**BELL BEND NUCLEAR POWER PLANT
REDACTION OF RESPONSE TO RAIs ENV-20 AND 21
BNP-2013-064 Docket No. 52-039**

Revised Redacted Version of BNP-2012-286, Attachment 2

RAI ENV-20
Question 5.3.2-3

RAI ENV-21**Question EIS 2.4.1-9**

Figure 1

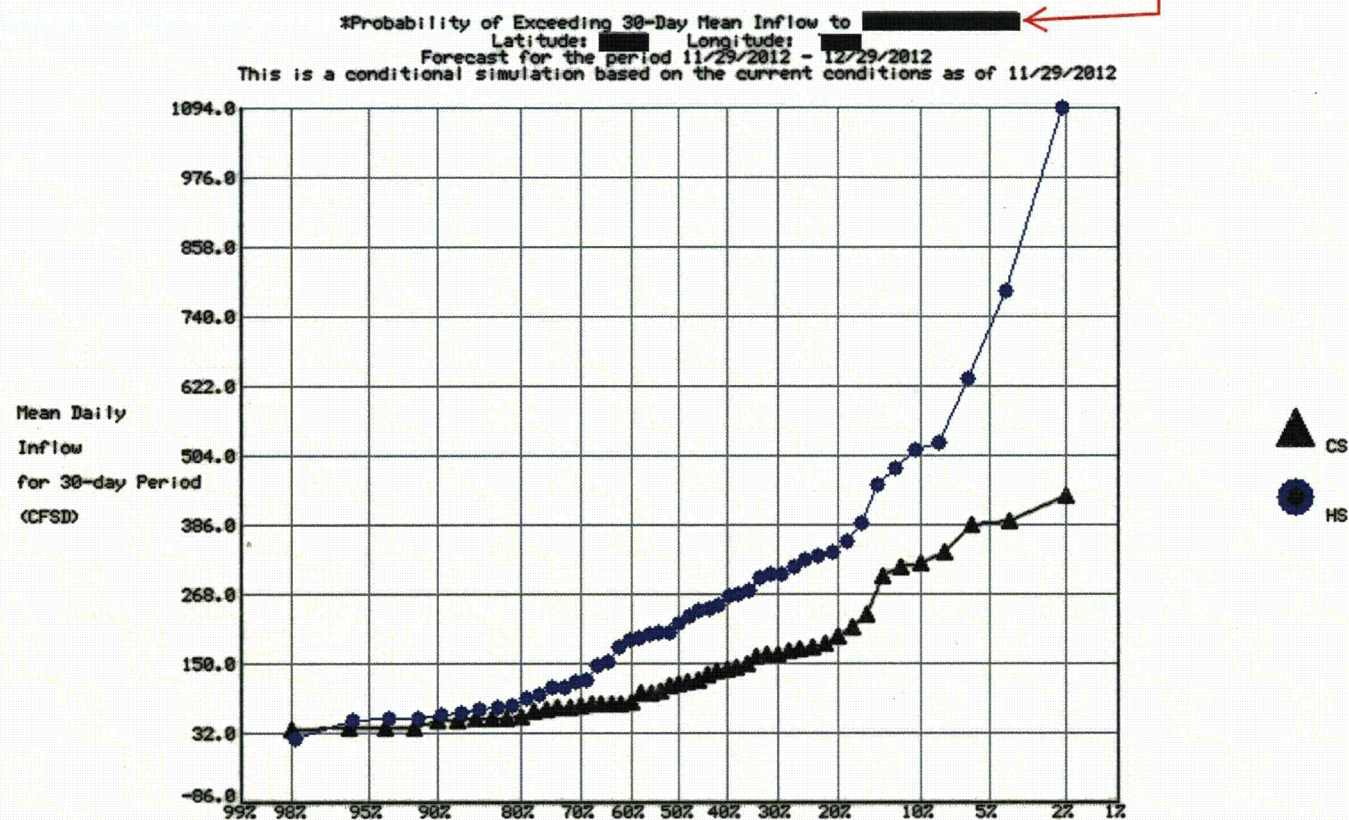
The conservation releases for consumptive-use make-up will occur during periods of low flow on [REDACTED]

[REDACTED]. The conservation releases will be within the banks of the river and be used to

maintain a normalized flow, (see Figure 1, below). Therefore, these releases are expected to have only positive impact on downstream users and ecological conditions.

Figure 2

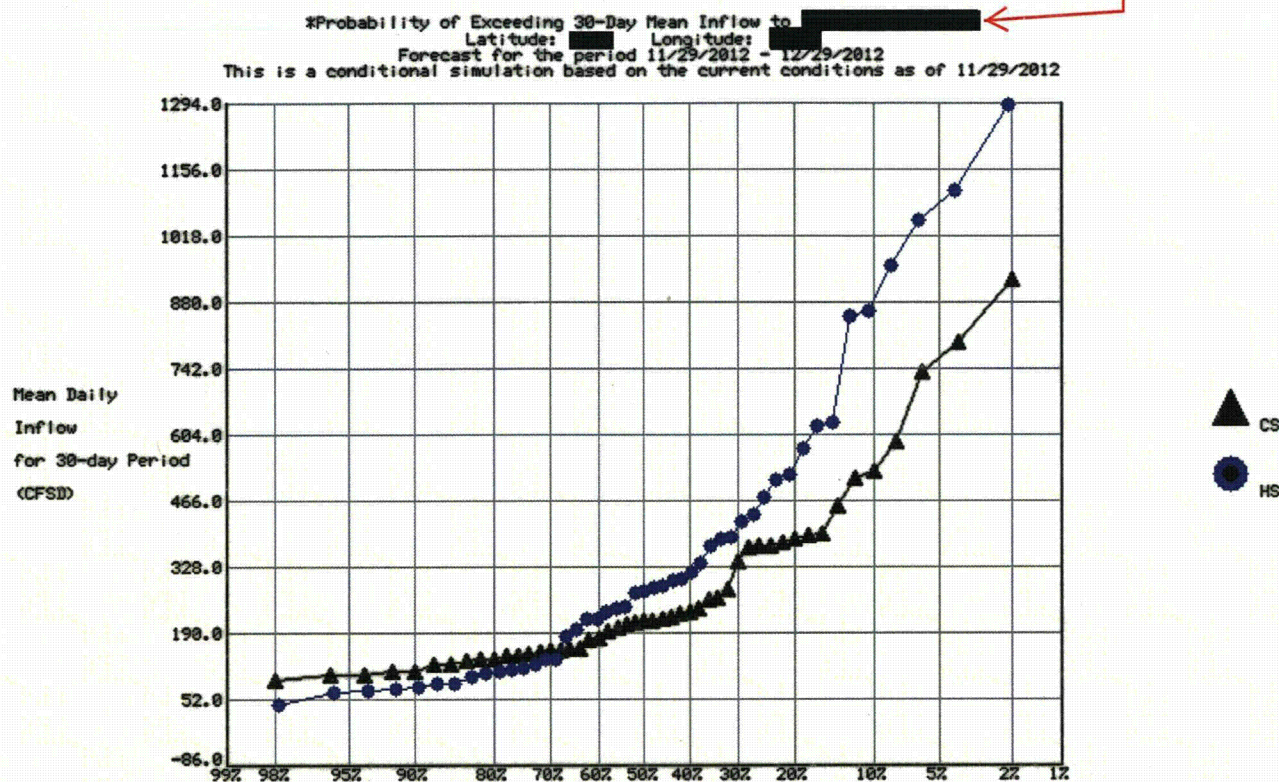
Request 3 "...describe the potential ecological effects of adding supplemental water to the water body at and downstream of the discharge point for each water source location and source type, such as impacts to habitat and aquatic species including important species as defined in Table 2.4.1-1 of the ESRP, such as ecological, commercial, and recreational species."

Resource "A" c. [REDACTED] 95% Probability of Exceeding 30-day Mean Inflow 95% value is approximately 32 cfs

Resource "B" d. [REDACTED] 95% Probability of Exceeding 30-day Mean Inflow 95% value is approximately 55 cfs.

In both cases the inflow to these reservoirs is close to the daily 43 cfs maximum consumptive-use mitigation.
